SERVICE BULLETIN

FUJI HEAVY INDUSTRIES LTD.

NO : FAS-047

1. SUBJECT : Addition of ICS installation.
2. AIRCRAFT AFFECTED : FA-200 Series serial Nos. 1 thru 101.
3. PRIORITY : Optional.
4. REASON : In order to facilitate cabin interphone.
5. DESCRIPTION : ICS AMP and relays to be installed behind instrument panel, under glove box, and press-to-talk switches attached on control wheels, with related electric system of wiring installed.
6. ACCOMPLISHMENT : Optional.
7. APPROVAL : JCAB Approved.
8. PARTS REQUIRED : The following parts are required to perform the modification.

FIG. 2 ICS AMP AND RELAY INSTALLATION

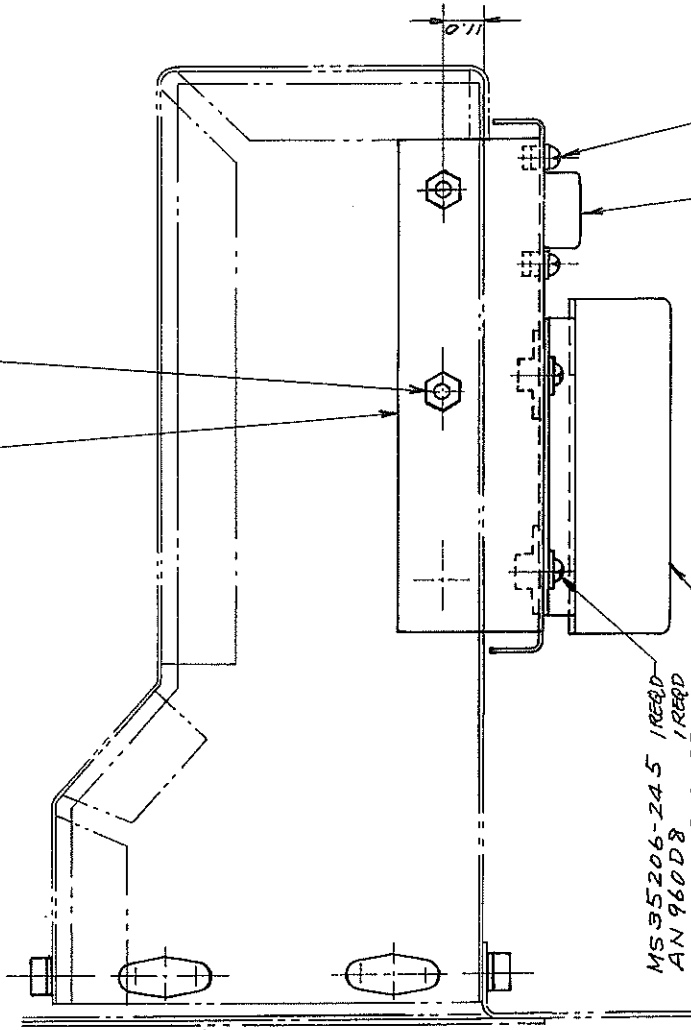
- (1) Remove auxiliary fuse box from instrument panel, and after installing nutplates, reinstall the box on instrument panel. (See Fig. 2.)
- (2) Install ICS AMP, 200-383400-001, and two relays, 200-383401-001, on bracket, 200-344231-001. (See Fig. 2.)

- (3) Install bracket, 200-344231-001, on auxiliary fuse box. (See Fig. 2.)
- (4) Install bracket, 200-344225-001, above instrument panel radio rack as shown in Fig. 1.

FIG 3 TERMINAL BLOCK INSTALLATION

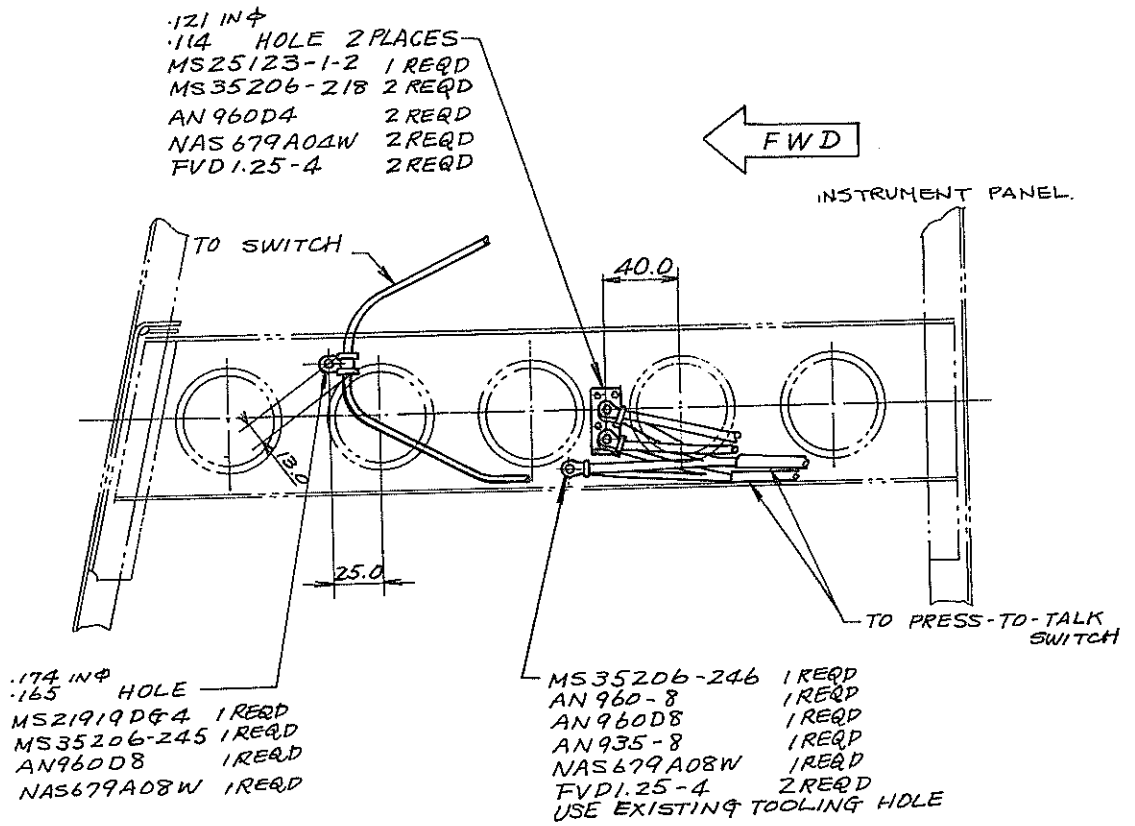
- (5) Install two switches, MS35059-23, on the above bracket as illustrated in Fig. 1.
- (6) Install terminal block on structure behind instrument panel as shown in Fig. 3.

FIG.4 PRESS-TO-TALK SWITCH INSTALLATION

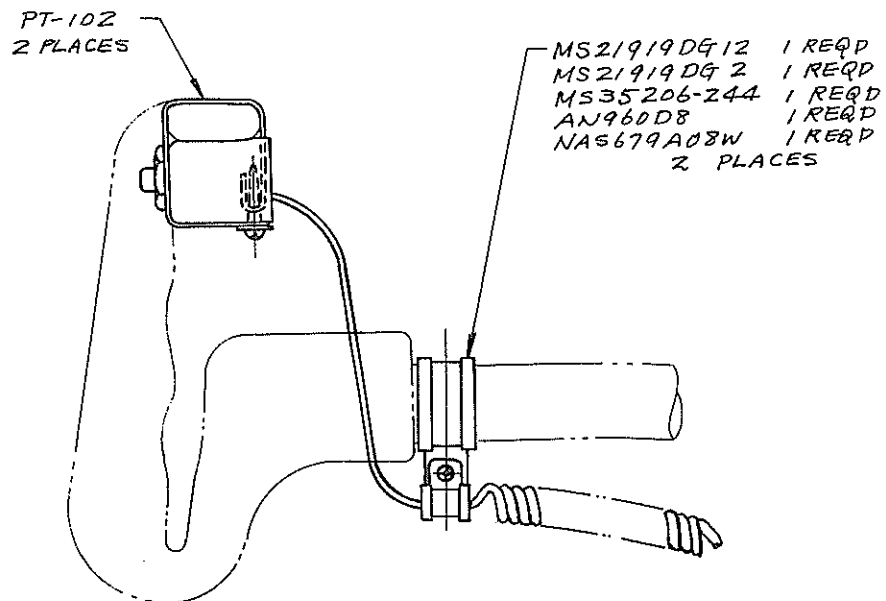
- (9) Connect electric system of wiring in accordance with Fig. 6, Wiring Diagram.
- (10) Install press-to-talk switch on each steering wheel, and lead wiring to terminal block. (See Fig. 1 and 4)

FIG. 5 WIRING DIAGRAM

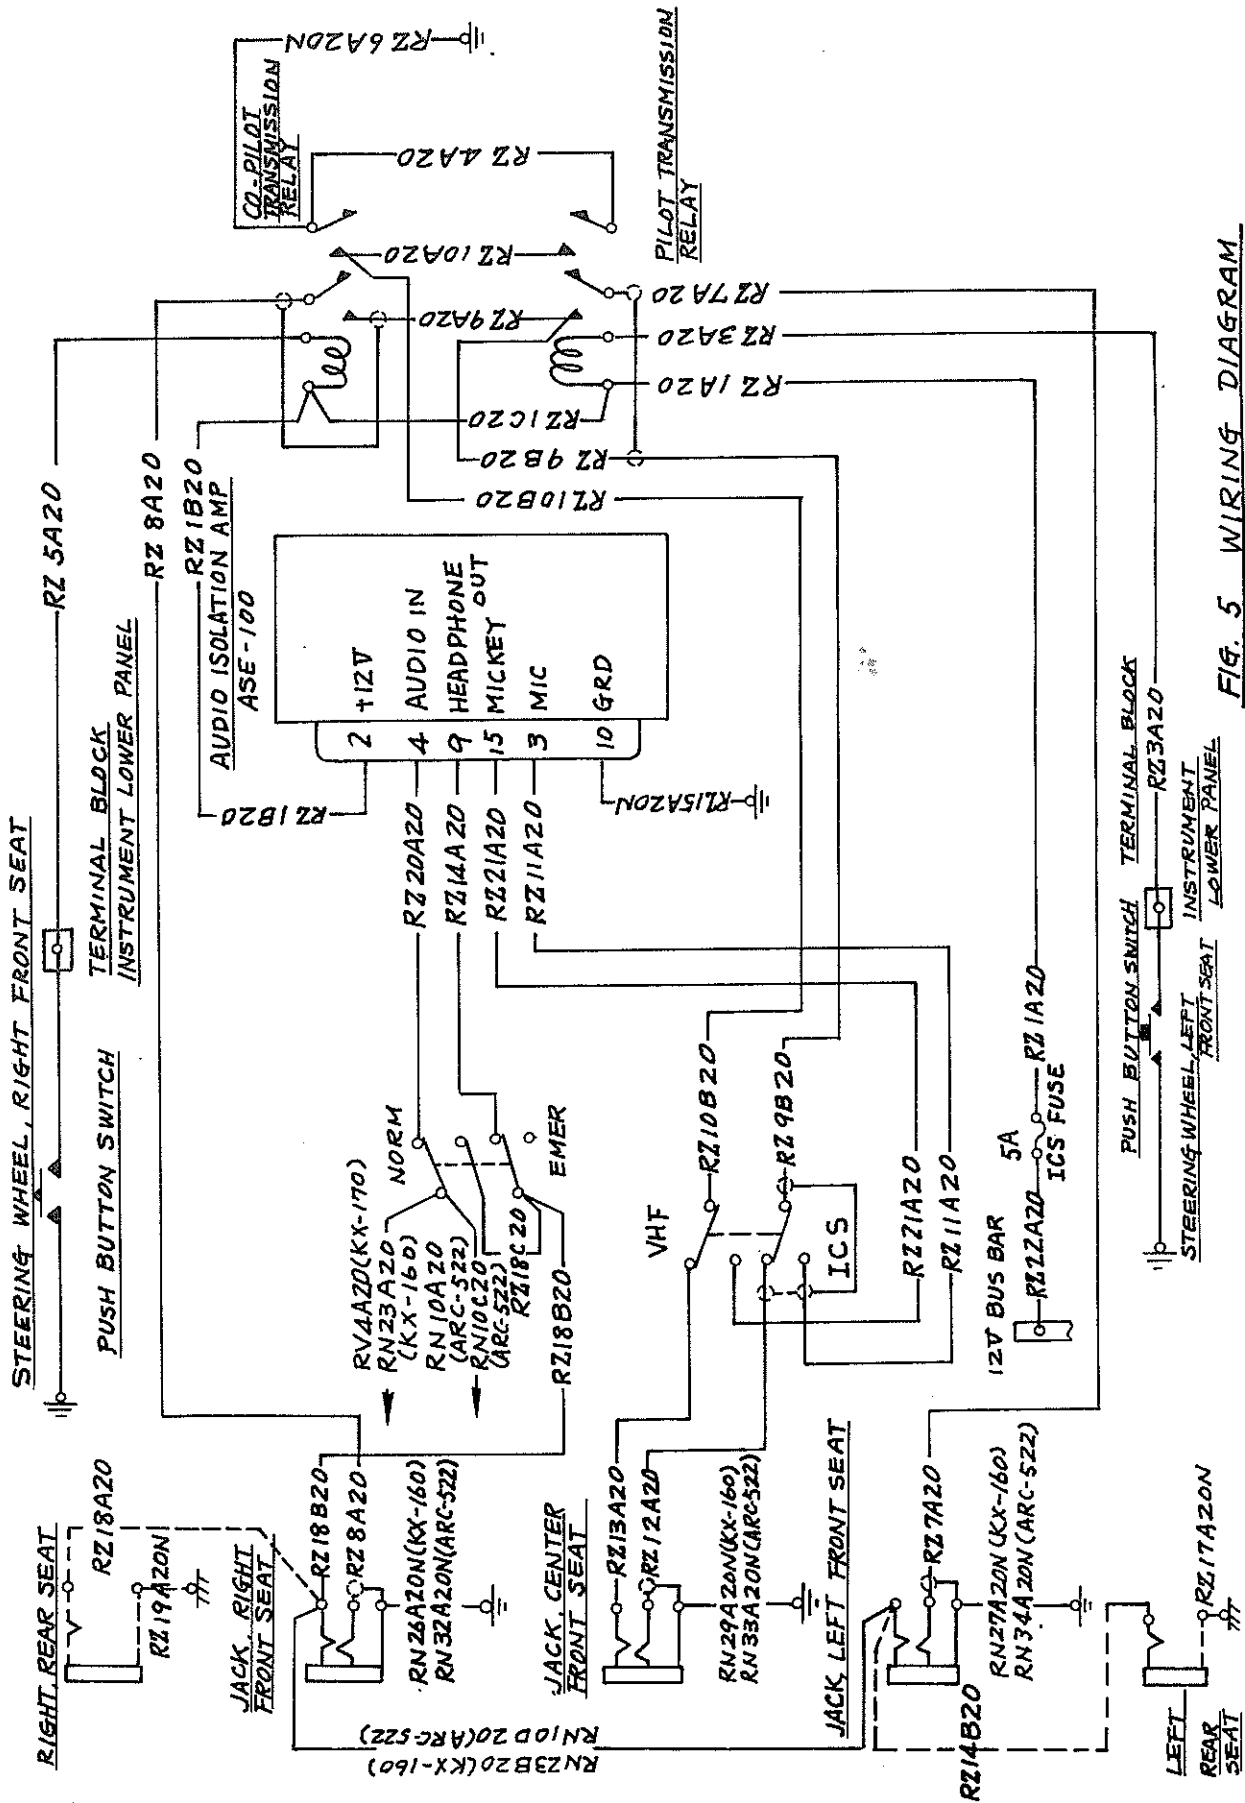
NOTE: REAR SEAT WIRING MAY BE INSTALLED AS OPTIONAL EQUIPMENT
